**Proposal Concerning the Deformable Barrier Specifications
 Proposed in TRANS/WP.29/GRSP/2002/6**

Transmitted by the Expert from Japan

With respect to the TRANS/WP.29/GRSP/2002/6 "Proposal for Draft Amendments to Regulation No.95 (Lateral Collision Protection)" presented by EEVC, Japan proposes that the static corridors for the Blocks 1&3 and Block 4 of Appendix 1 of Annex 5 be amended as shown in Figure 1a&1b below.

Fig. 2 Distribution of Dynamic and Static Loads

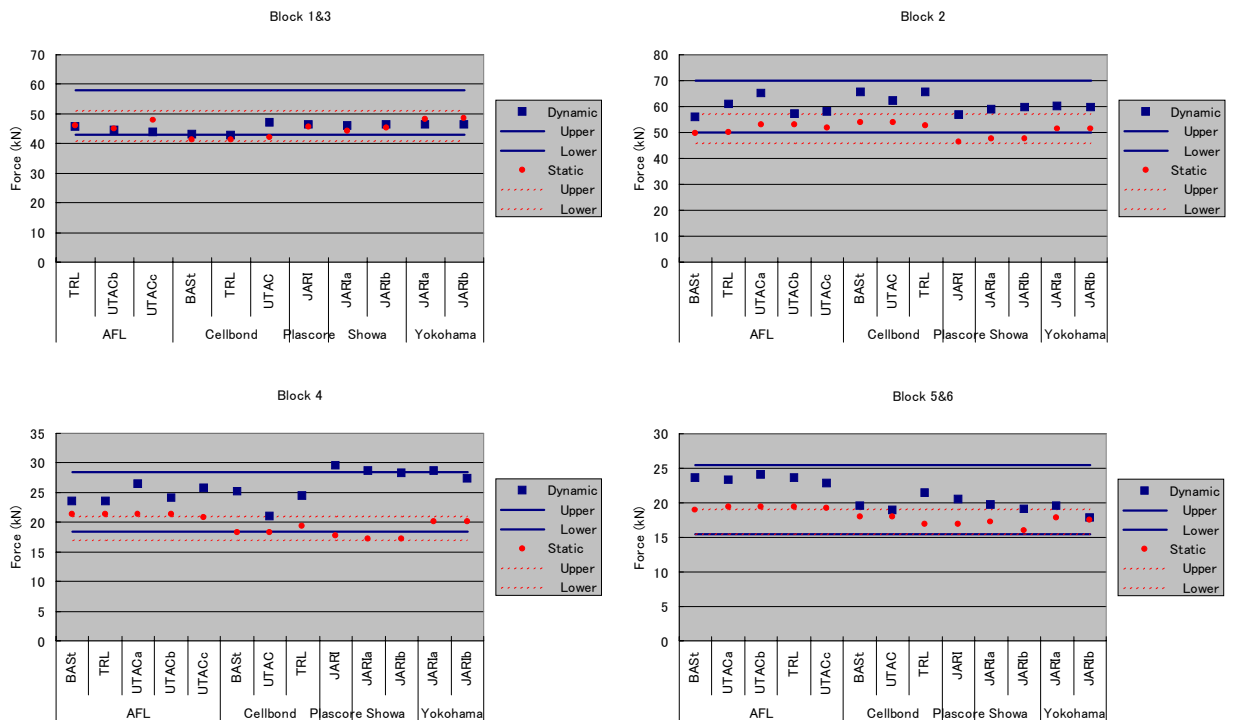
From the results of the Japanese tests and the European evaluation results distributed at the recent EEVC WG13 subgroup meeting, the static-dynamic ratio was calculated for each block of the D/B. The dynamic and static loads in the area where the load-displacement characteristics become horizontal (displacement of 305 mm over for Blocks 1, 3, 4, 5 and 6 and 165 mm over for Block 2) are shown in Figure 2. The calculated static-dynamic ratios are given in Table 2.

Fig. 3 Amended Static Corridors

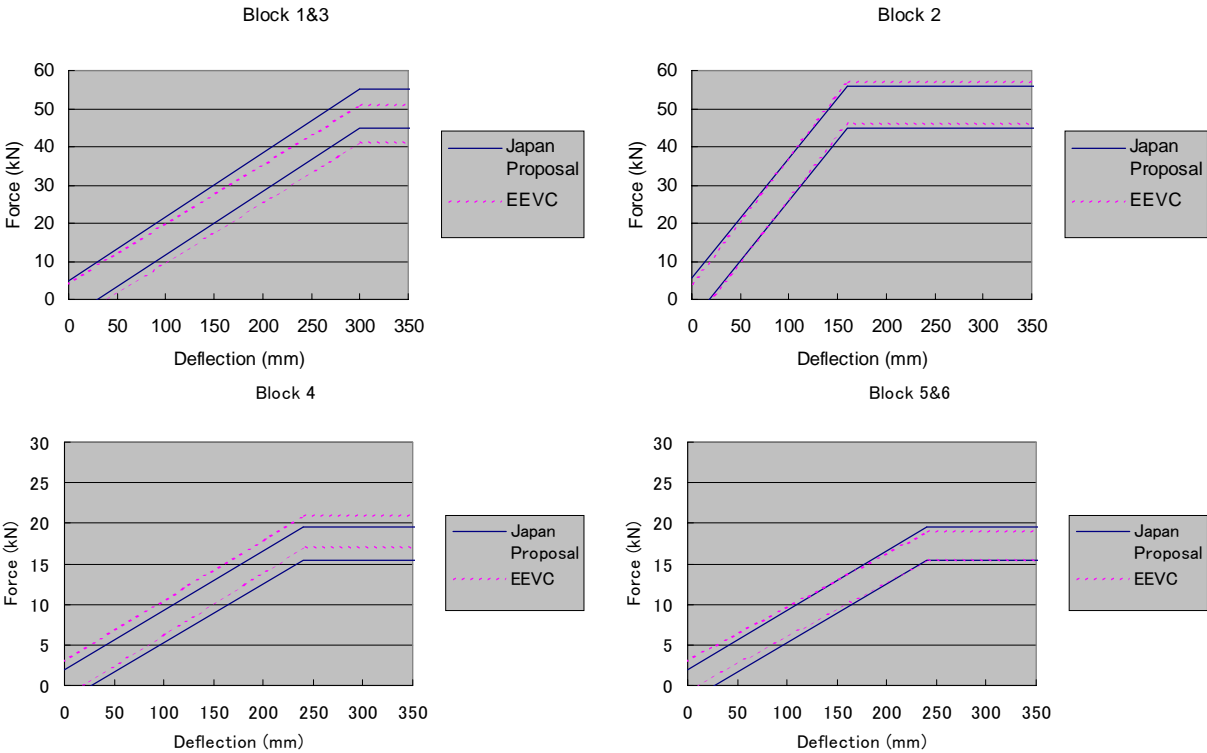
On the basis of the results shown in Table 3, the static corridors were amended as shown in Figure 3, while the width of the each corridor was kept identical with that of the static corridors proposed by EEVC.

Fig.2 Force-Deflection Curves of Block 2

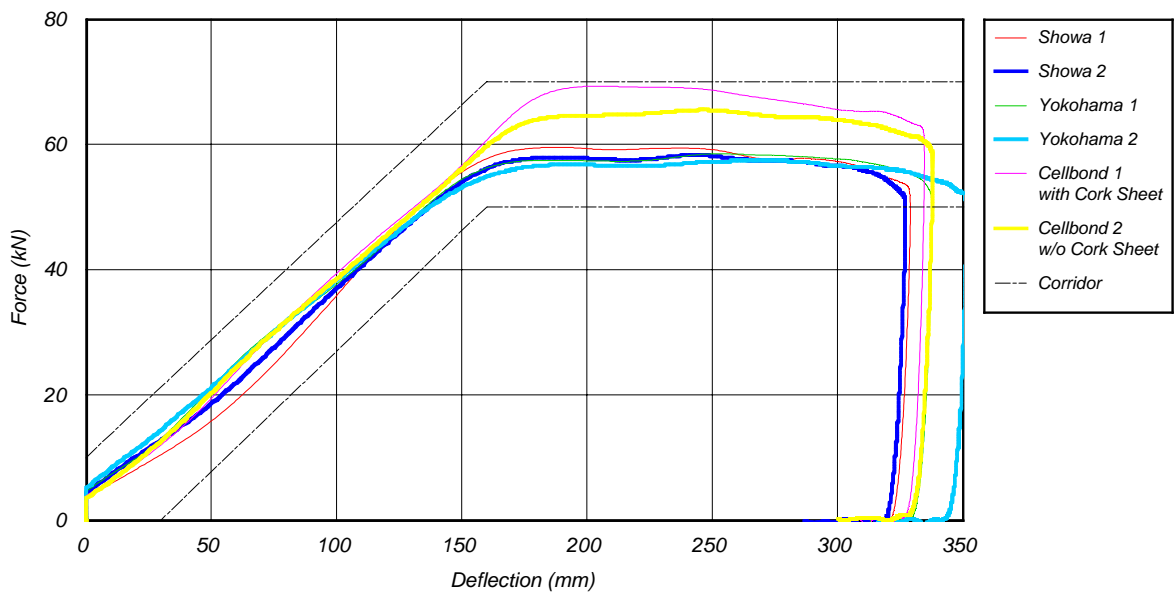
The force-deflection characteristics were stipulated in the draft not only for the corridor of a conventional dynamic test but for that of a static test as well. All three barriers displayed practically the same tendencies for all blocks and for the overall dynamic characteristics. Block 2 of the Cellbond barrier had a higher load than those of the other barriers, and the load became even larger when the cork sheet was used. As for the static characteristics, those of the

Fig.4 Force-Deflection Curves of Block 4

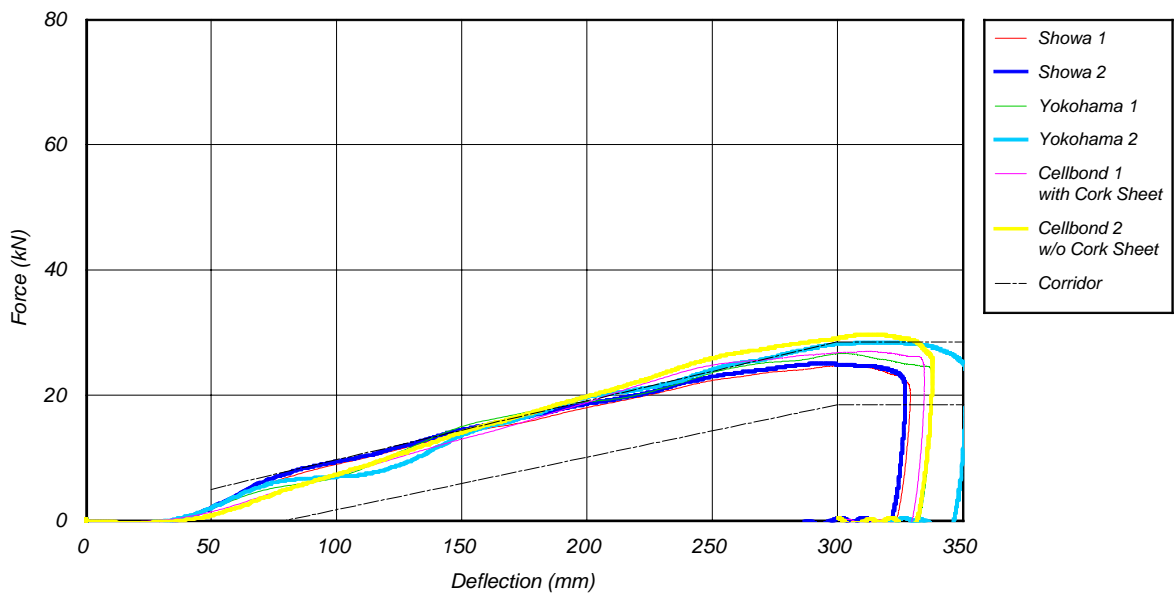
Yokohama Rubber and Cellbond barriers stayed for the most part in the middle of the corridor, whereas Showa lowered the Block 4 characteristics below the corridor values so that they would be the same as the Block 5 and Block 6 characteristics, after receiving the results of previously conducted development tests.

Fig.8 Deflection of Test Vehicles

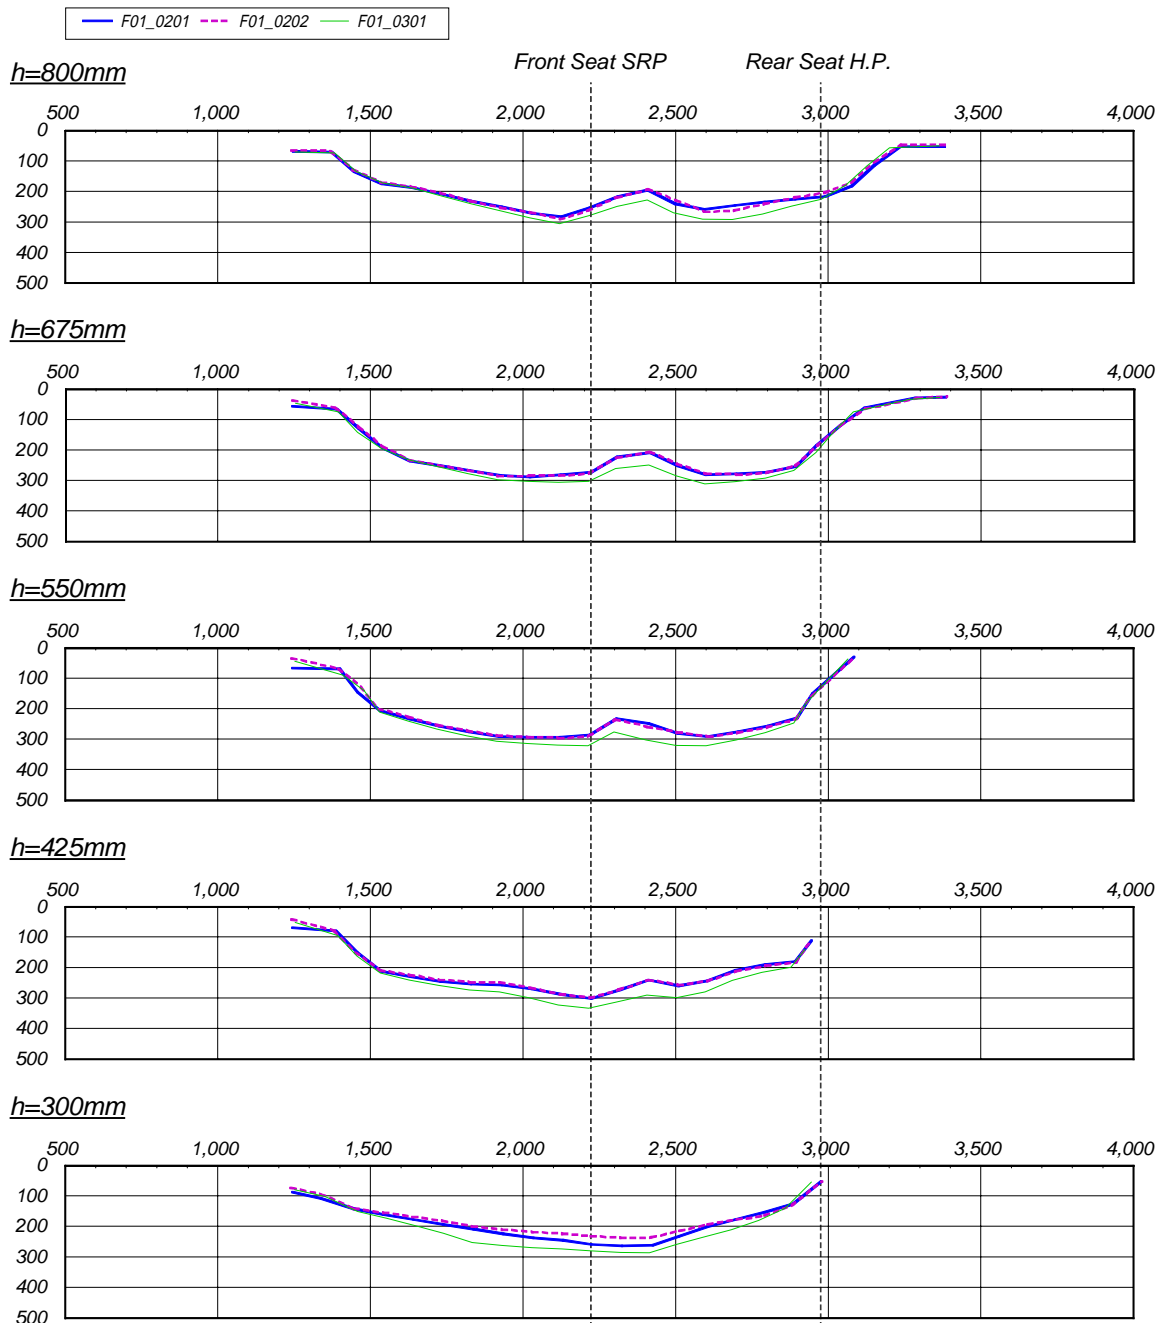
When the three types of progressive barriers were compared, it was found that the Showa and Yokohama Rubber test results had practically the same vehicle deflection values and deflection modes. On the other hand, the deflection values in the Cellbond tests, tended to be about 50 mm greater at maximum deflection, even though the deflection modes were the same as in the other tests.
